**SUSQUEHANNA STEAM ELECTRIC STATION  
RESPONSE TO REQUEST FOR ADDITIONAL  
INFORMATION ON TECHNICAL SPECIFICATION  
CHANGES TO RCS PRESSURE AND  
TEMPERATURE (P/T) LIMITS  
PLA-7299**

**Docket No. 50-387  
and No. 50-388**

**Response to Requested Additional Information**

### **Revised TS Figures 3.4.10-1 Through 3.4.10-3, Units 1 and 2**

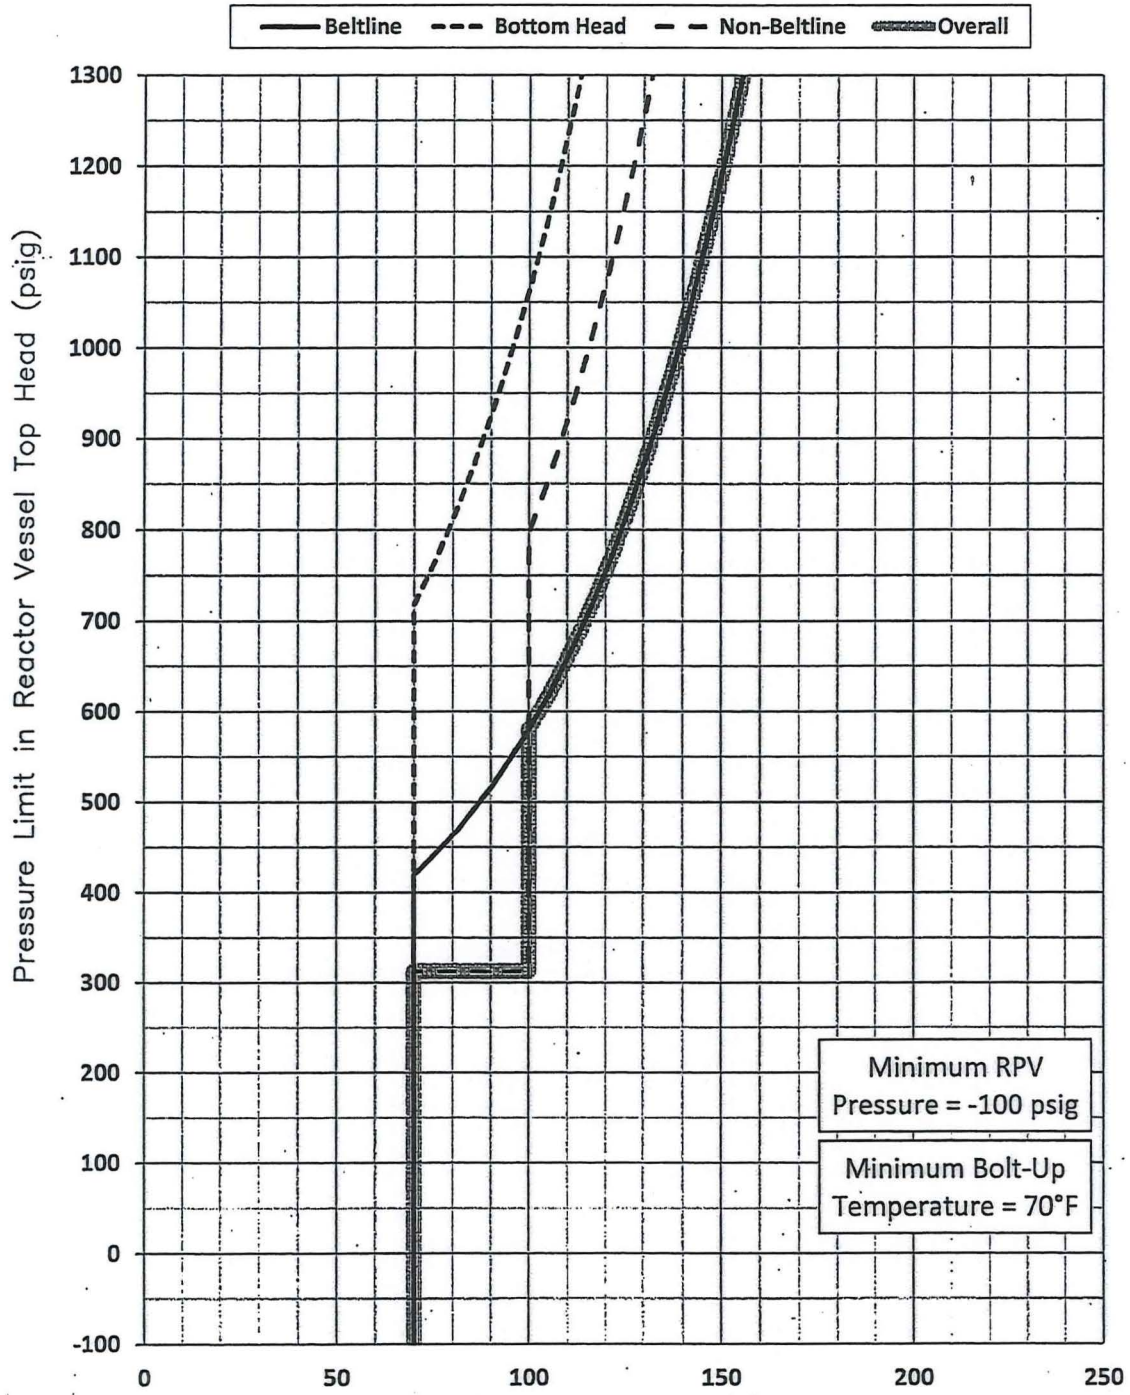
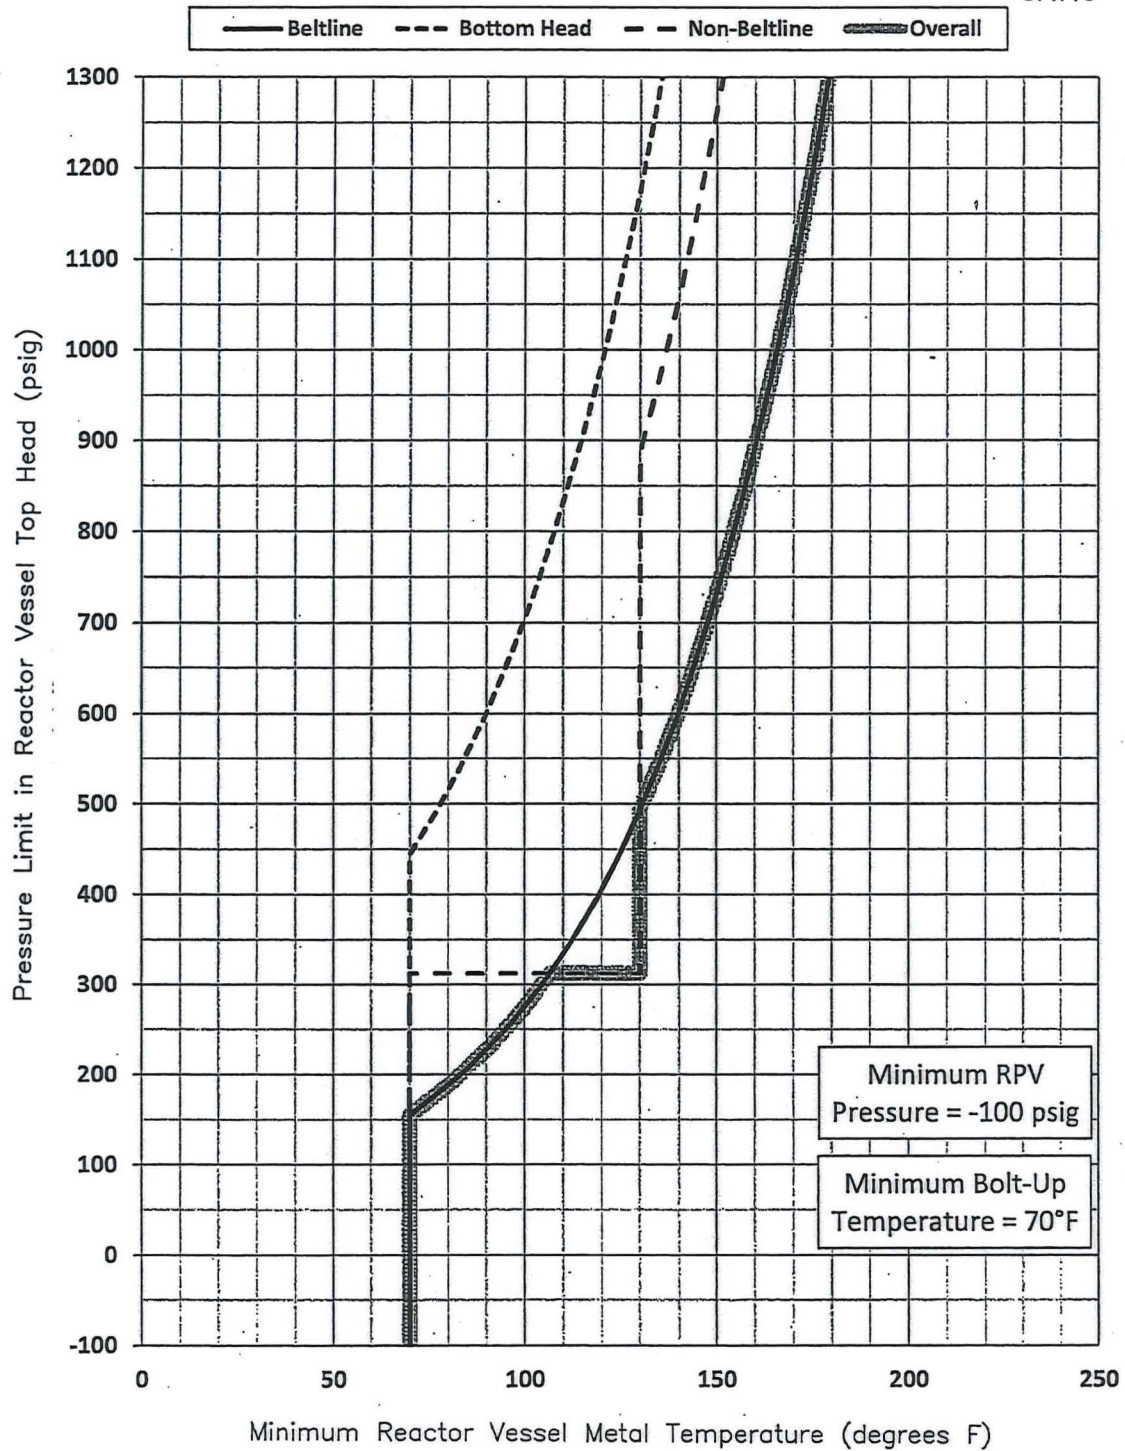
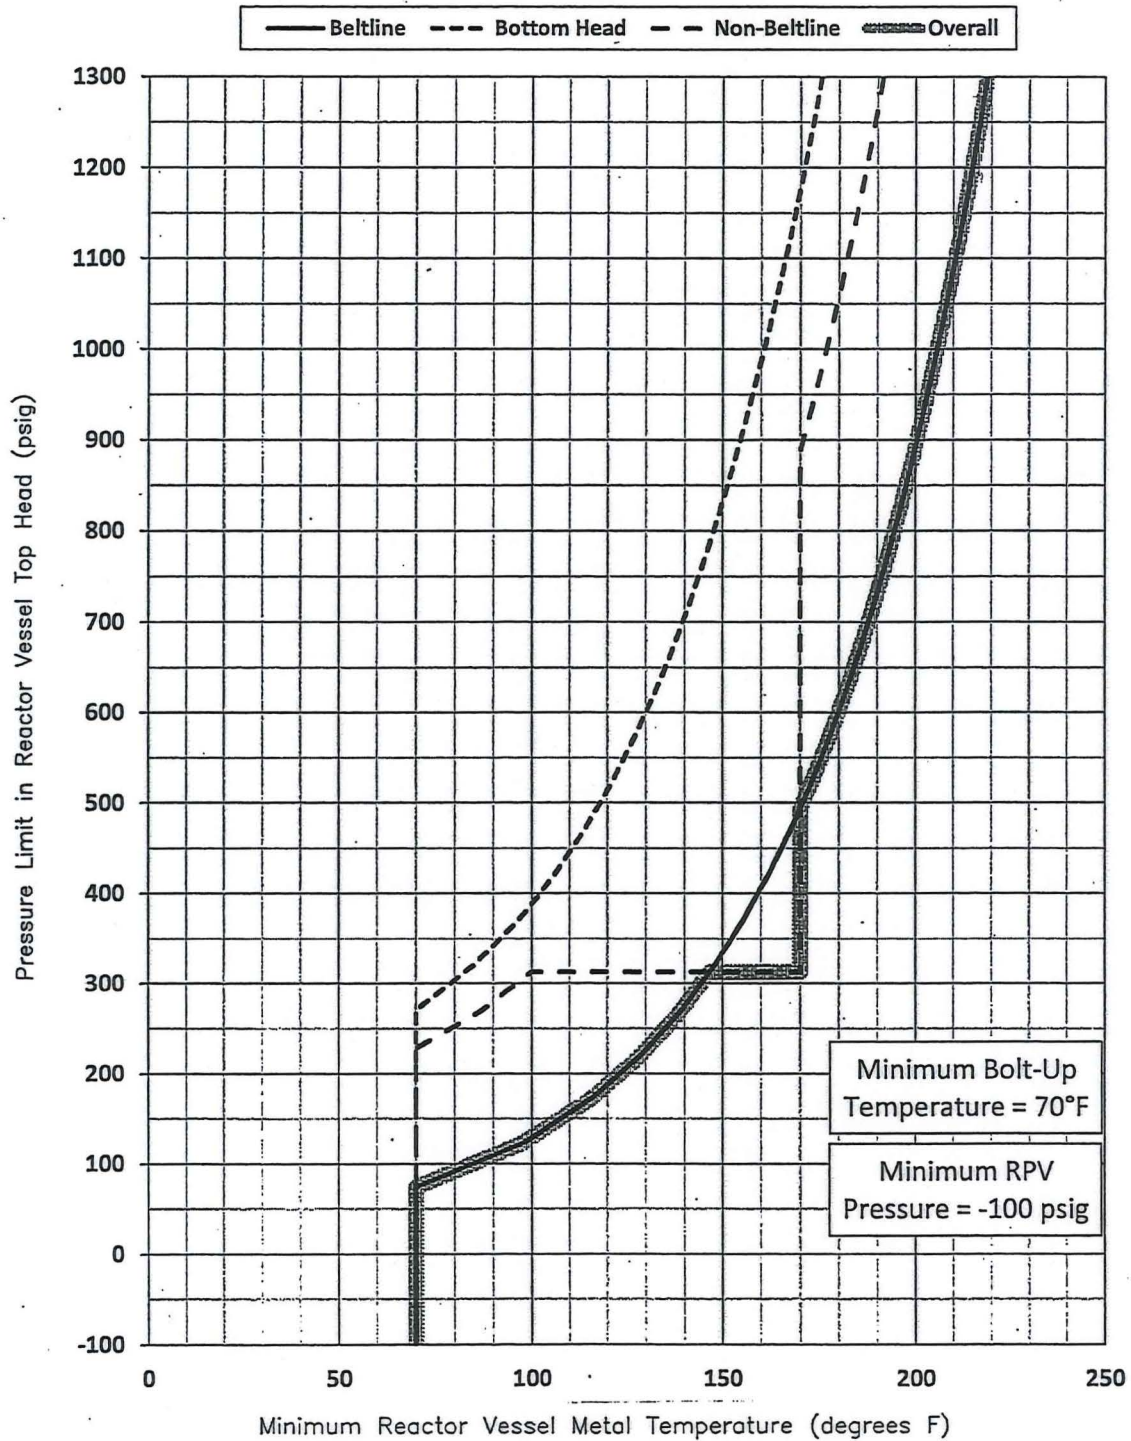
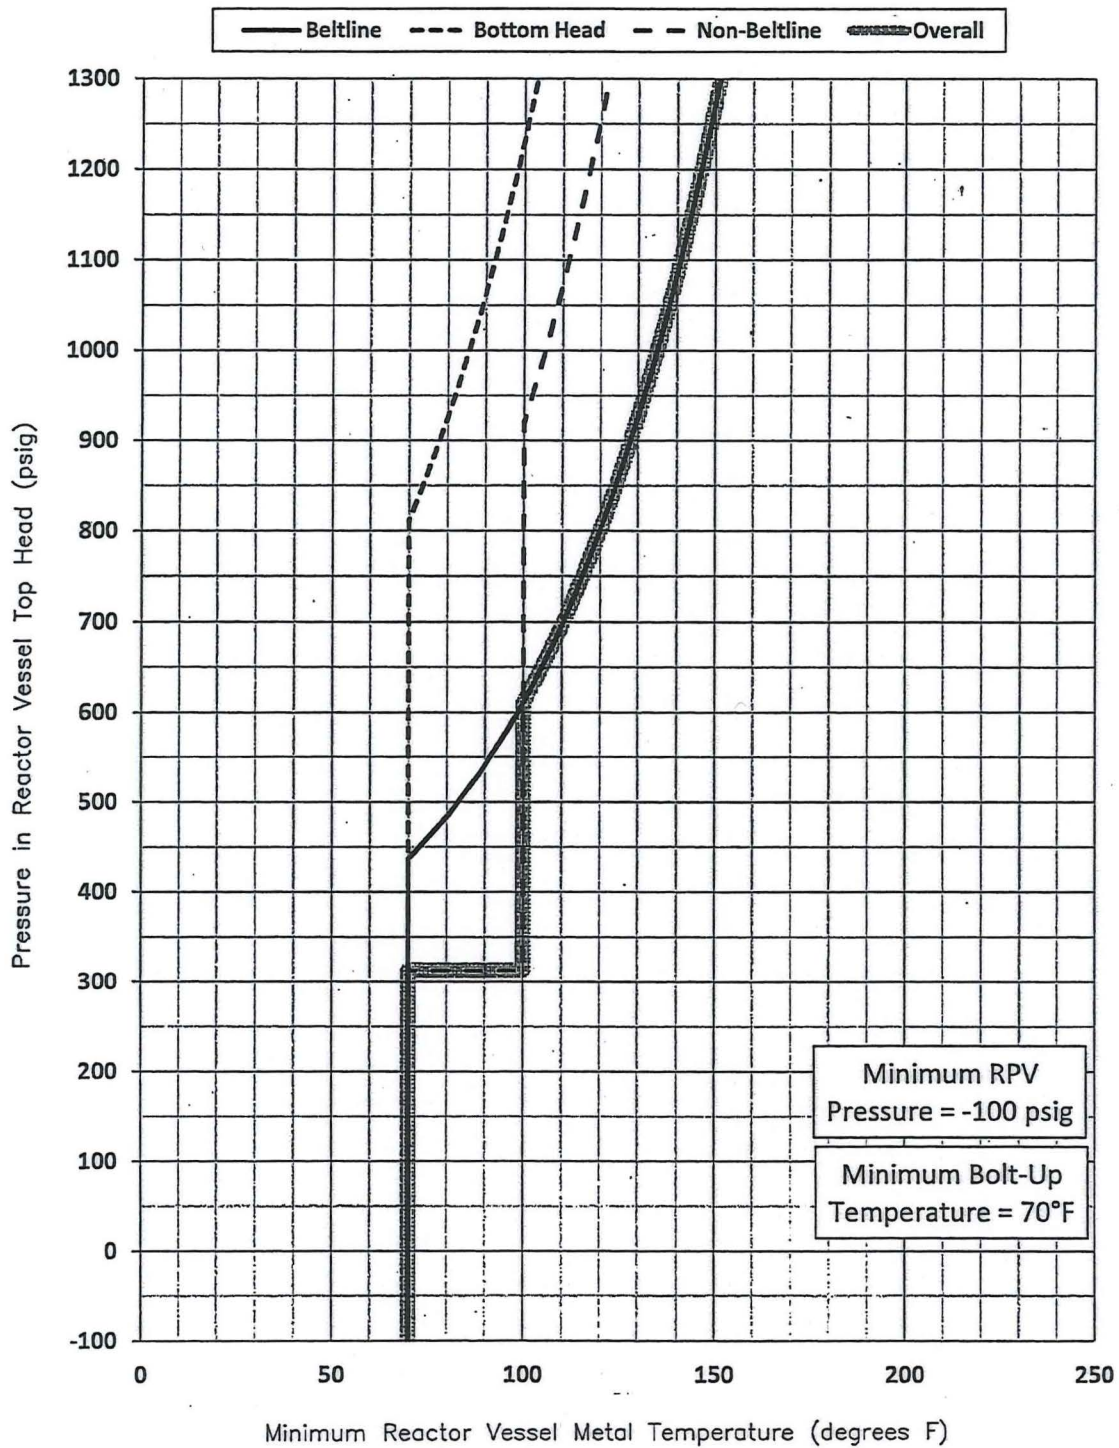
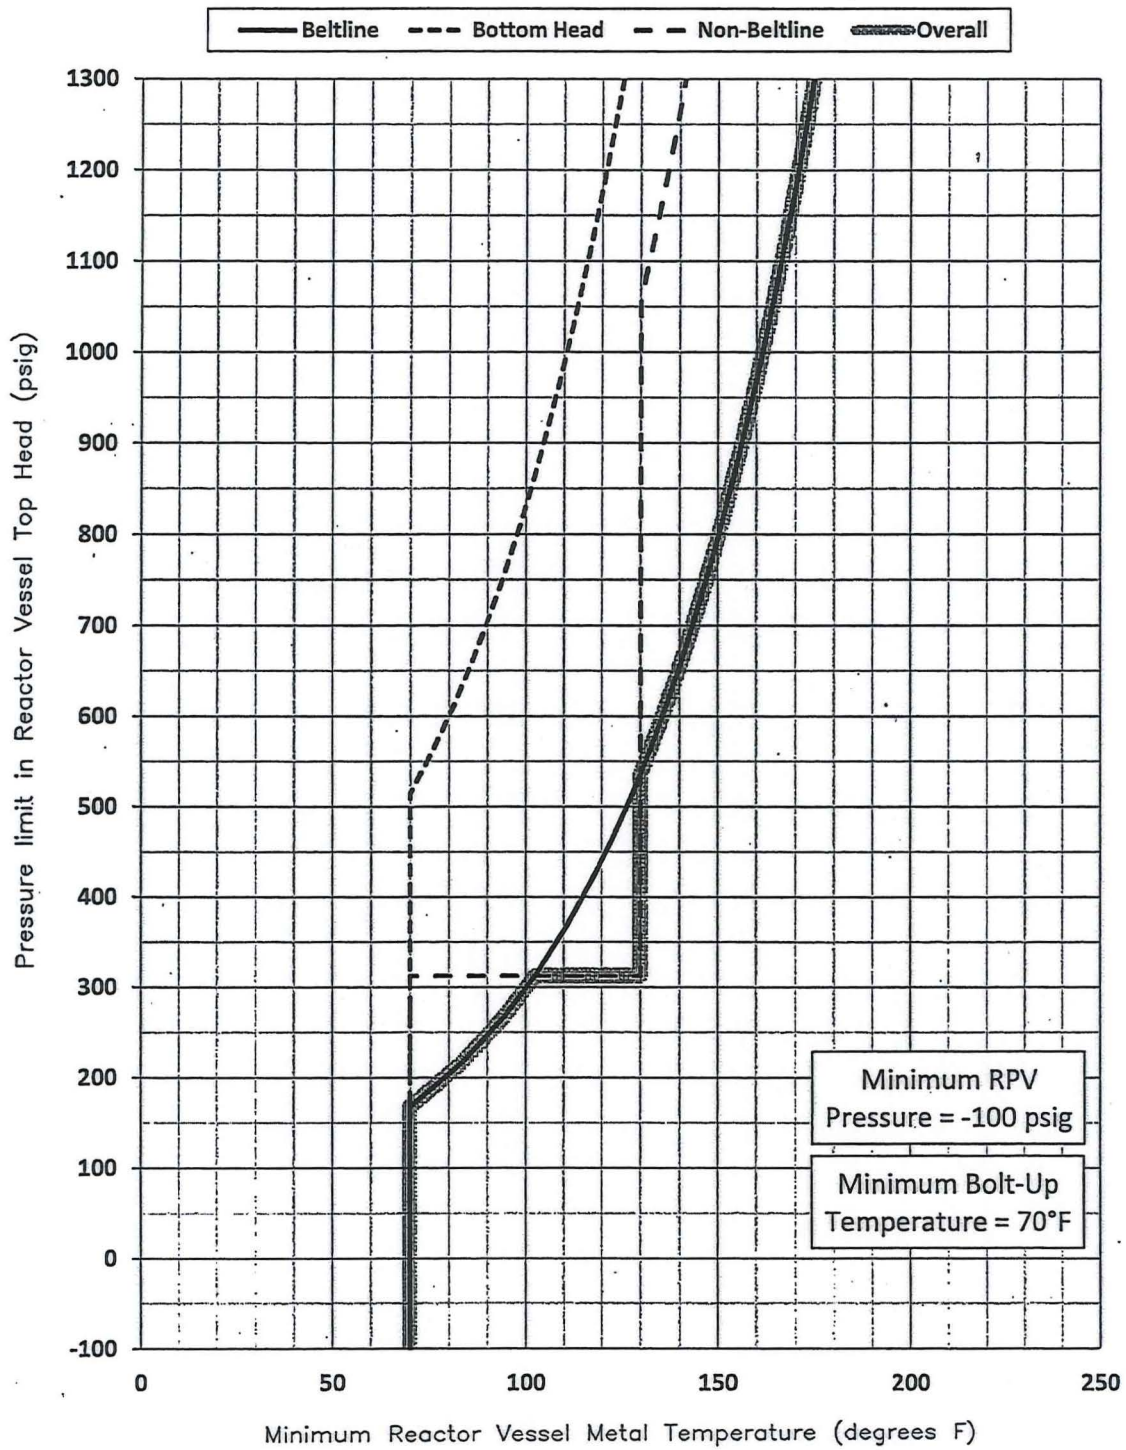
Whereas the licensee's proposed Technical Specifications (TS) change on TS Figures 3.4.10-1 through 3.4.10-3 shows P/T limit curves are extended to -100 psig. Any TS change should be consistent with the technical justification.

Please provide a justification for an extension of the P/T curves to -100 psig, or, TS Figures 3.4.10-1 through 3.4.10-3 should be revised to reflect the maximum vacuum of -15 psig as described in the submittal (i.e., adjusting the axis to end at -15 psig, terminating the P/T curves at -15 psig on the current scale, etc.).

The technical justification for allowing an extension of the P/T curves to -100 psig is provided in Attachment 3, which demonstrates that the P/T limits applicable at 0 psig are also applicable at negative pressures and that the RPV maintains structural margin at -100 psig.

The statement on Page 3 of 7 of the application (Reference 1), which states, in part, "The absolute maximum vacuum is assumed to be no greater than 15 psig," recognizes the fact that there is no possibility of drawing the RPV to greater than an absolute vacuum (approximately -14.7 psig). However, as detailed in Attachment 3, it is possible for the RPV to also experience an external pressure of approximately 2 psig due to drywell pressurization. In this case, the effective pressure on the RPV would be -16.7 psig (-14.7 psig - 2 psig). Thus, there is a possibility, albeit remote, for the RPV to experience an effective internal pressure of -16.7 psig, which does exceed an absolute vacuum.

It is also recognized that there is potential variance and uncertainty in the measured steam dome pressure under a vacuum, using the installed instrumentation. By extending the P/T curves to -100 psig, PPL's intention is to avoid future concerns should any vacuum reading ever exceed -15 psig. The extension to -100 psig is expected to cover any reasonably foreseeable variance in steam dome vacuum measurement.

A final point in response to this RAI is that the extension of the P/T curves to -100 psig matches the scale and format of the existing P/T curves (i.e., pressure values are in increments of 100 psig). Furthermore, extending the scale to -100 psig, even though the RPV will never experience such a vacuum, is analogous to the upper limit of 1300 psig on the P/T curves, which would also be unattainable, assuming the RPV safety relief valves operated per design. During startups/heatups, the operators would not pressurize the RPV significantly beyond 1000 psig.
